# Access Compliance Report

## Public Rights-of-Way

Intersection ID: 8513	Main Street: MCARTHUR_AV	Cross Street: MONTREAT_ST	Location: SW
ADA ID: 900097991399	Ramp Type: Perp	Initial Pass/Fail: Fail	Overall Compliance: No
Severity Score: 13.75			
Codes/Mitigation Info/Possible Solution		Field Measurements/Component Compliance

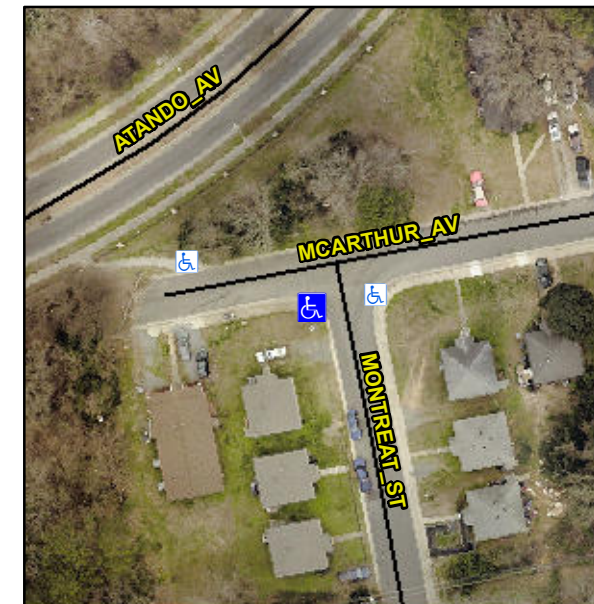
**Not Found, R304.2.2, R304.5.3**

Compliance	Description	Data	Compliance	Description	Data
N/A	Ramp Length (in)	62.0	No	Ramp Slope (%)	9.1
Yes	Ramp Width (in)	63.0	No	Ramp XSlope (%)	4.6
N/A	Flare Type LT	N/A	N/A	Flare Type RT	N/A
N/A	Flare Slope LT (%)	N/A	N/A	Flare Slope RT (%)	N/A
N/A	Flare Traversable LT?	N/A	N/A	Flare Traversable RT?	N/A
N/A	Landing Length (in)	N/A	N/A	DWS Provided?	N/A
N/A	Landing Width (in)	N/A	N/A	DWS Contrast?	N/A
N/A	Landing Slope (%)	N/A	N/A	DWS Length (in)	N/A
N/A	Landing X Slope (%)	N/A	N/A	DWS Full Width?	N/A
N/A	Landing Curb? (Y/N)	N/A	N/A	DWS Offset (in)	N/A
N/A	Shared Landing?	N/A			
N/A	Gutter Ponding?	N/A	N/A	Gutter Slope (%)	N/A
N/A	Gutter Lip Ht (in)	N/A	N/A	Gutter X Slope (%)	N/A
N/A	Painted X Walk1?	No	N/A	Painted X Walk2?	N/A
	X Walk 1 Direction	To E		X Walk 2 Direction	N/A
N/A	X Walk 1 Width (in)	N/A	N/A	X Walk 2 Width (in)	N/A
	X Walk 1 Slope (%)	3.9		X Walk 2 Slope (%)	N/A
	X Walk 1 X Slope (%)	4.8		X Walk 2 X Slope (%)	N/A

**Remove & Replace Entire Ramp.**
